**TOWN OF DAVIE
TOWN COUNCIL AGENDA REPORT**

SUBJECT: Site Plan, SP 11-7-05, Oak Landings, 6401 SW 41st Street/ Oak Landings,
6401 SW 41st Street/ Generally located on the north side of SW 41st Street
approximately 600 feet west of Davie Road.

TOWN OF DAVIE
Development Services Department
Planning and Zoning Division Staff
Report and Recommendation

1. Site Plan
2. Future Land Use Map
3. Zoning and Aerial Map
4. Public Participation Report

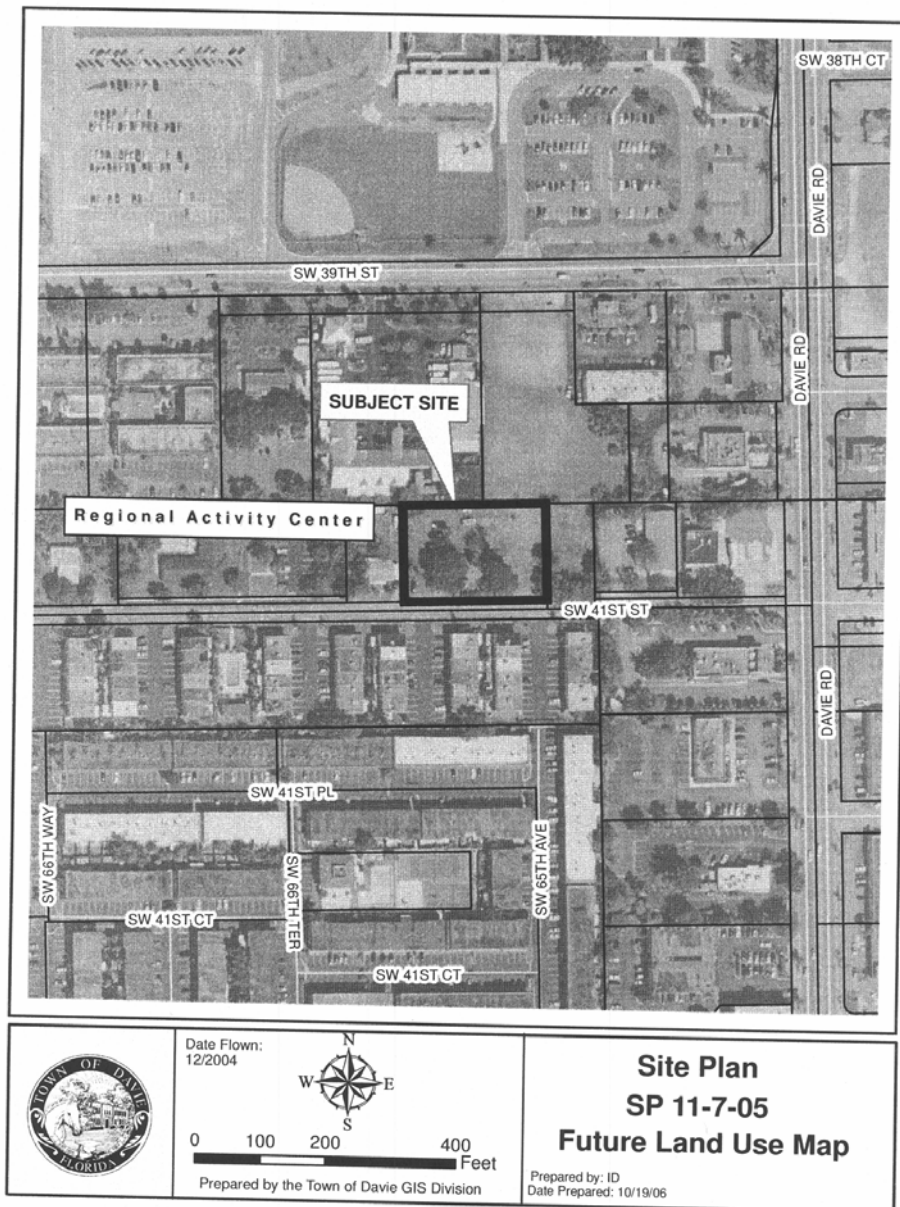
At the October 10, 2006 Site Plan meeting, Mr. Aucamp made a motion, seconded by Ms. Aitken, to approve based on staff's comments and the following: 1) the applicant is to work with staff to increase the width of the compact parking spaces to ten-foot wide

where possible and subject to Engineering's approval that the sidewalks could be reduced to four-foot widths; 2) the chain-link fence will be black vinyl-clad; 3) to replace the front five hardwood trees to five Royal Palms, four-foot grey wood; and 4) if the two Live Oaks and one Slash Pine do not make it through the construction process, the applicant must replace them caliber-inch for caliber-inch on the site. If there is no room on the site, they can donate them to the Town. **(Motion carried 3-0)**

Please note: The applicant has met with Engineering Department and agreed to reduce the sidewalks to enlarge the guest parking spaces (item #1).
